Response to Submissions and Additional Information

Liverpool Hospital - Integrated Services Building
and Refurbishment Works Corner Elizabeth Street
and Goulburn Street, Liverpool

Submitted to Department of Planning Industry and
Environment

09 September 2020 | 218264

Figure 1 Proposed Goulburn Street entry forecourt

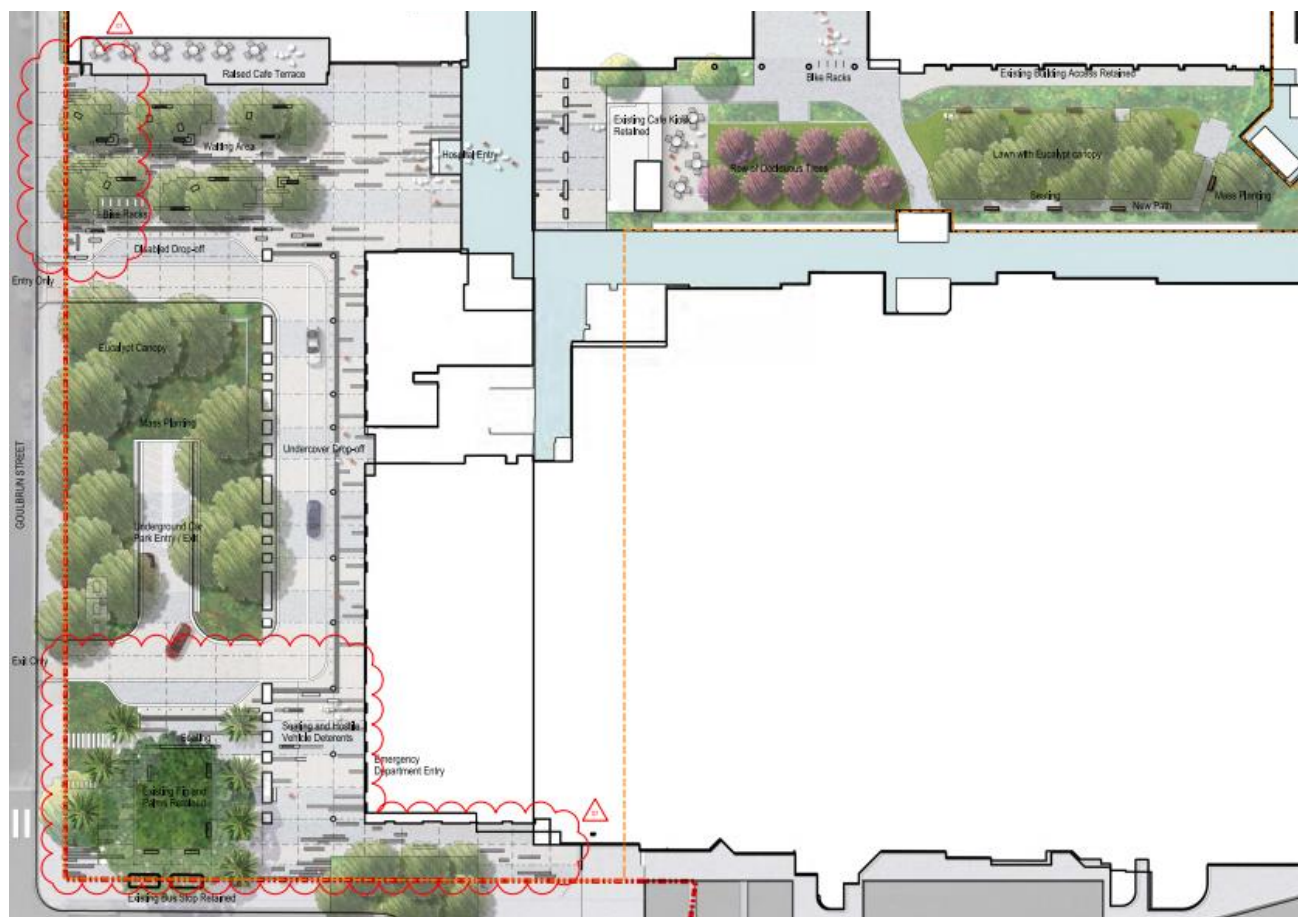
Liverpool City Council have raised concerns with regards to the proposed landscaping and public domain works along Goulburn Street as well as the removal of some trees, including the *Corymbia citriodora*. As part of ongoing consultation post exhibition, Council have requested that the proposal outline the change in canopy cover across the site.

The amended Landscape Plans prepared by Clouston included at **Appendix D**, illustrate an improved design transition from the Goulburn Street footpath (granite) to the forecourt paving (concrete with granite band) as well as additional granite banding at the boundary. The site's Goulburn Street frontage will also provide additional seating at the forecourt near the corner of Elizabeth Street. This is shown at **Figure 1** and **Figure 2** below.

Figure 3 Existing overland flow analysis (south)

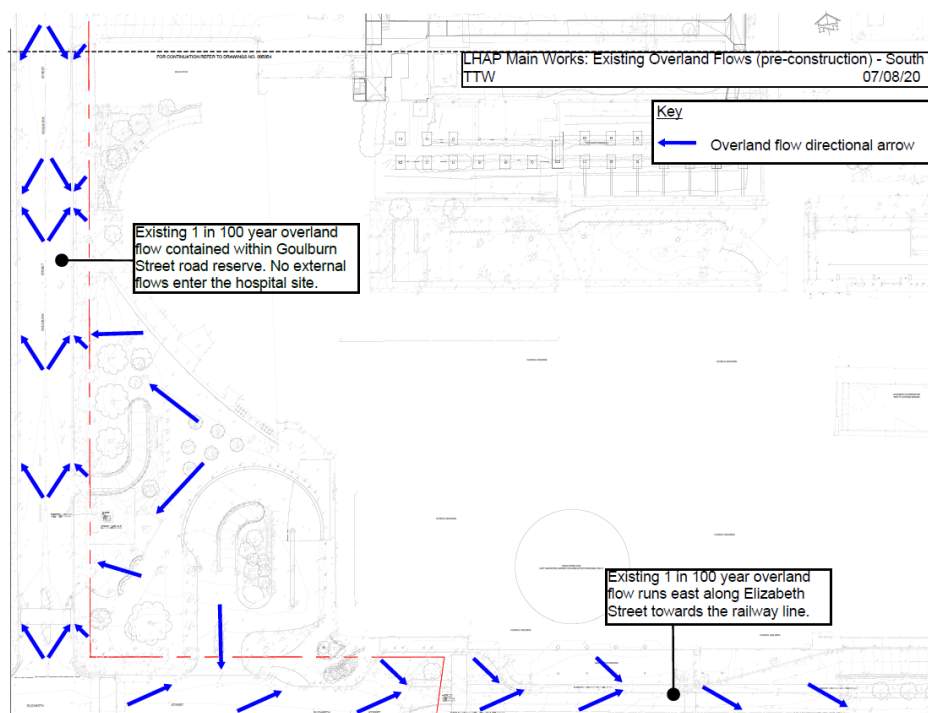
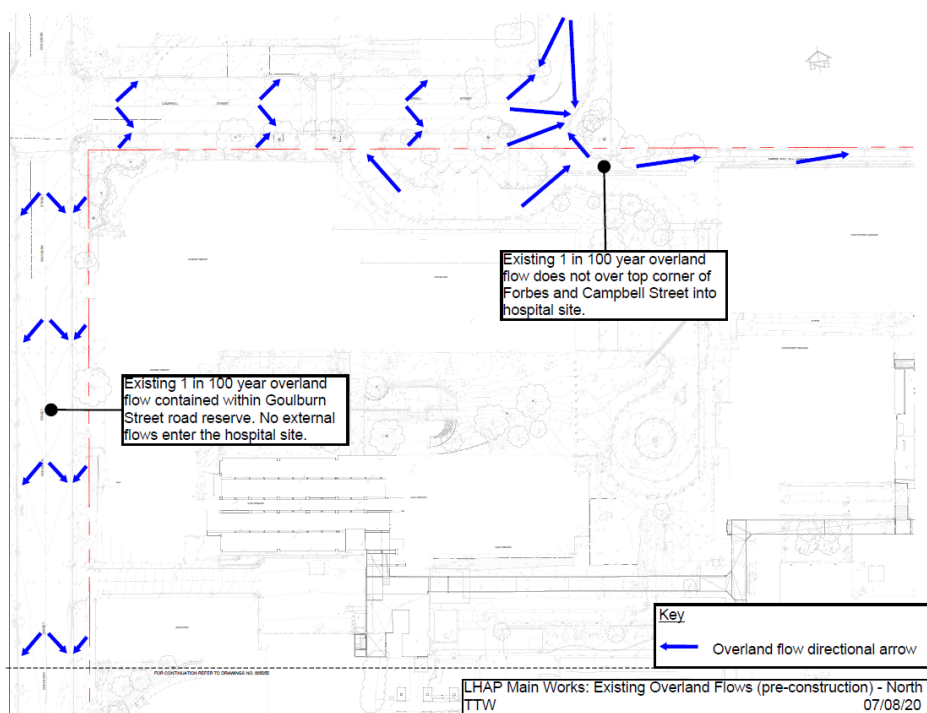
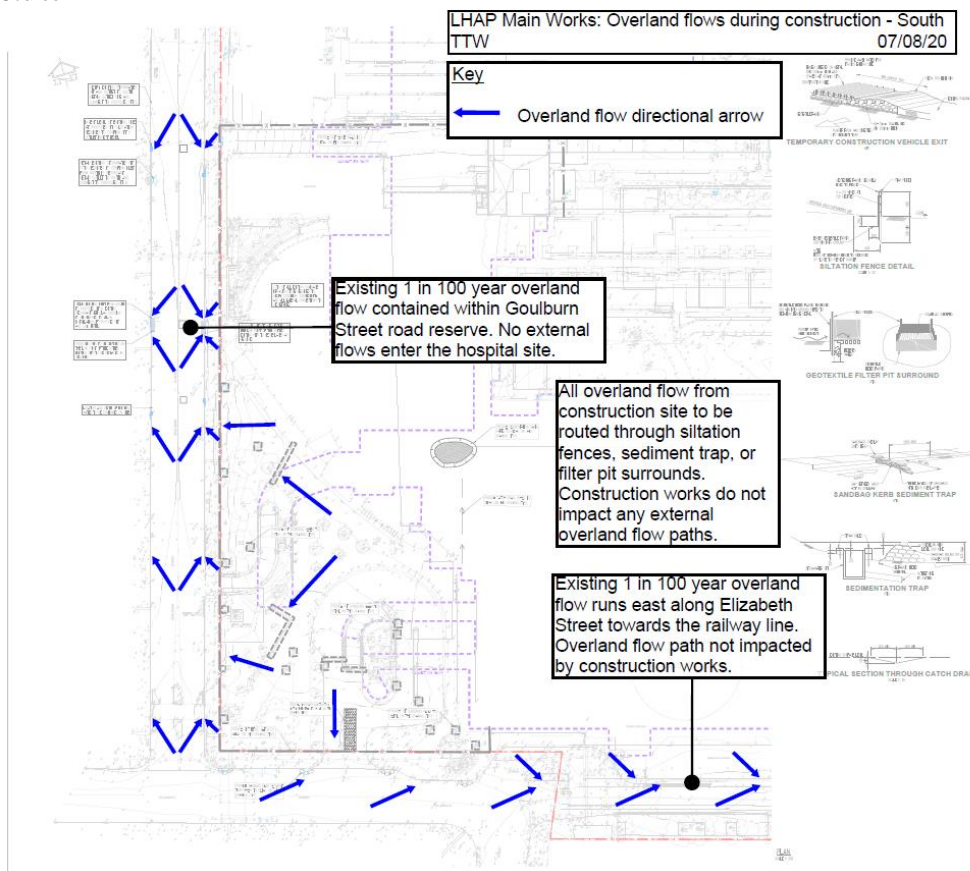
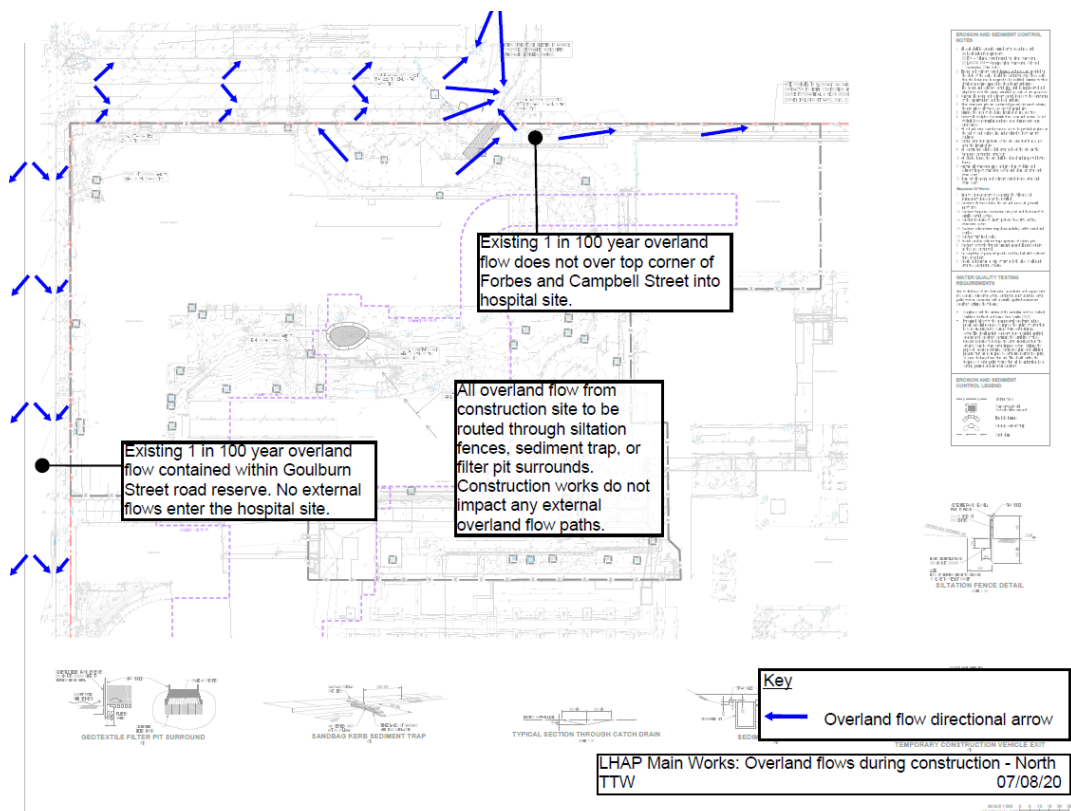
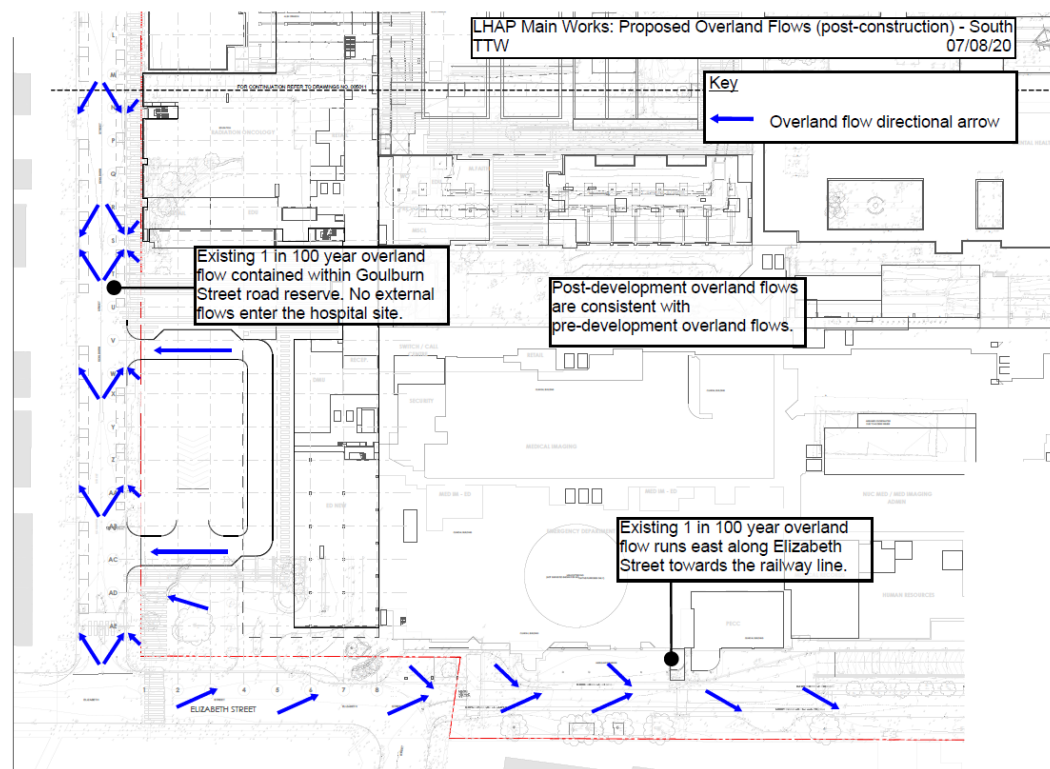
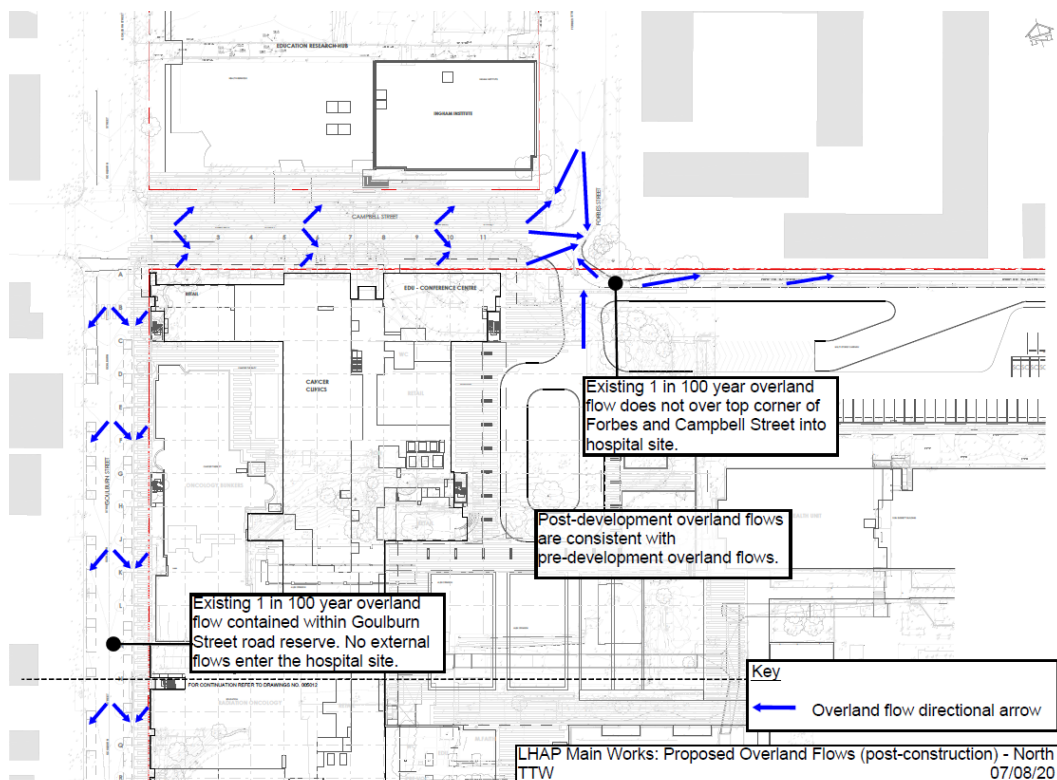
The applicant sought clarification of the DPIE request regarding flooding and DPIE seeks information on how stormwater would be managed during construction and following the completion of construction, given that flows would be altered during the construction of the development and once it is complete.

Plans illustrating the existing, during construction and post construction overland flow directions have been prepared by TTW. The plans illustrate that all overland flow from the construction site will be managed through siltation fences, sediment traps or filter pits. As shown in **Figure 3** to **Figure 8** below, the proposed construction works will not impact any external overland flow paths and during the post development scenario, overland flows are consistent with the pre-development overland flows. The overland flow path analysis is included at **Appendix L**.

Figure 9 Basement Level – proposed location of staff bicycle parking and end of trip facilities

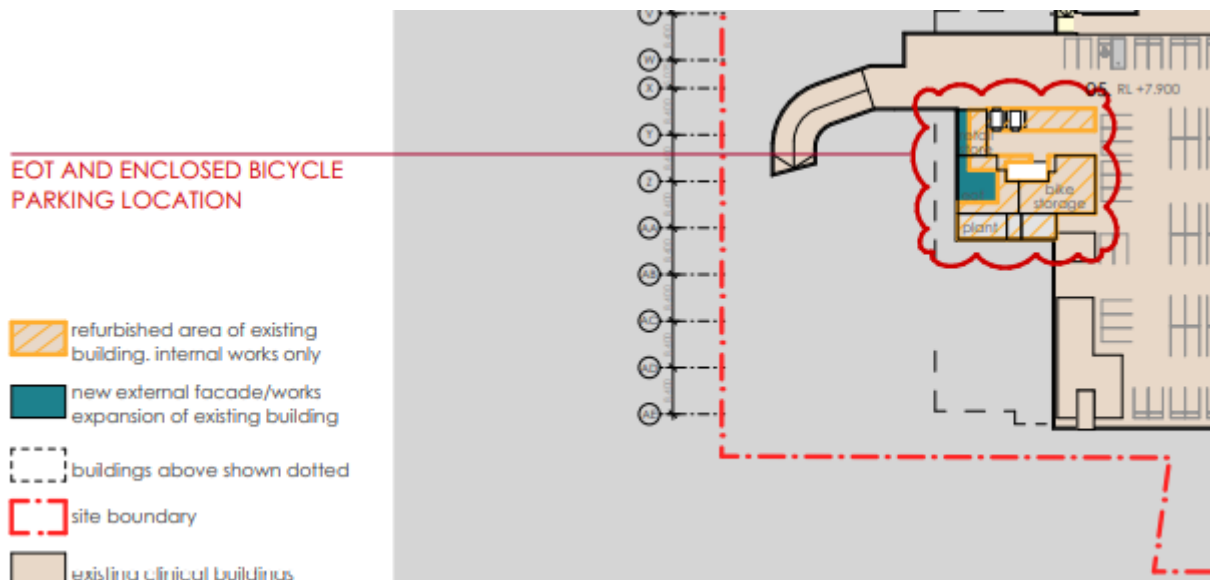
In response to the issues raised by Liverpool City Council and Transport for NSW, the proposed amended design has incorporated additional bicycle parking and end of trip facilities on the hospital campus. It is noted that by 2025/26, there will be an additional 418 full time equivalent staff working at the Liverpool Hospital campus, and assuming average staff per weekday shift (ASDS) is approximately 80% of FTE staff, this results in around 330 ASDS equating to a minimum provision of 34 bicycle parking spaces. Therefore, as detailed below, the provision of bicycle parking for staff is considered adequate to encourage a mode shift towards cycling, as well as meeting any existing demand that is not already satisfied.

A portion of the Basement Level of the existing Old Clinical Services Building is proposed to be demolished and refurbished to accommodate additional bicycle parking spaces and end of trip facilities. These works will also include the expansion of the building line to accommodate the additional facilities. Accordingly, the P1 basement car park will accommodate 50 secure bicycle parking spaces and associated end of trip facilities to service staff. The proposed location of the Basement Level bicycle parking and end of trip facilities is shown in **Figure 9** below.

Figure 11 Southern podium façade amendments

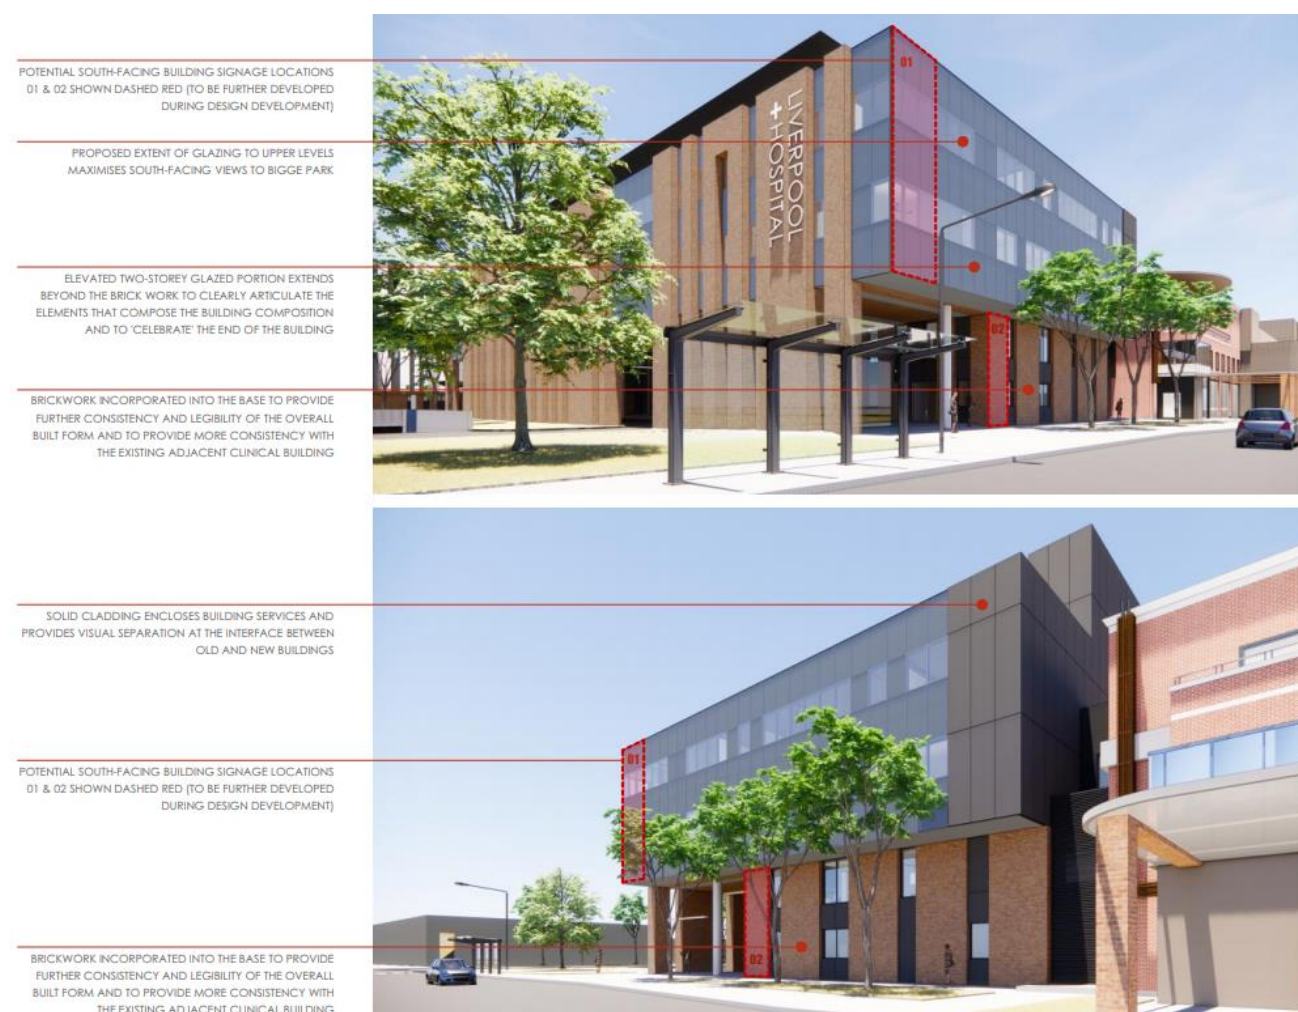
In response to the issues raised by Council regarding the aesthetics of the proposed development, the southern façade of the podium has been amended. Additional brick elements on the lower levels of the podium will provide a more sensitive response to the adjacent Clinical Services Building and further consistency and legibility of the overall built form along the streetscape. The use of solid cladding will further provide visual separation between the adjacent Clinical Services Building and glazing on the upper levels will maximise south facing views to Bigge Park. The proposed southern façade amendments are discussed in **Appendix B** and shown in **Figure 11** below.
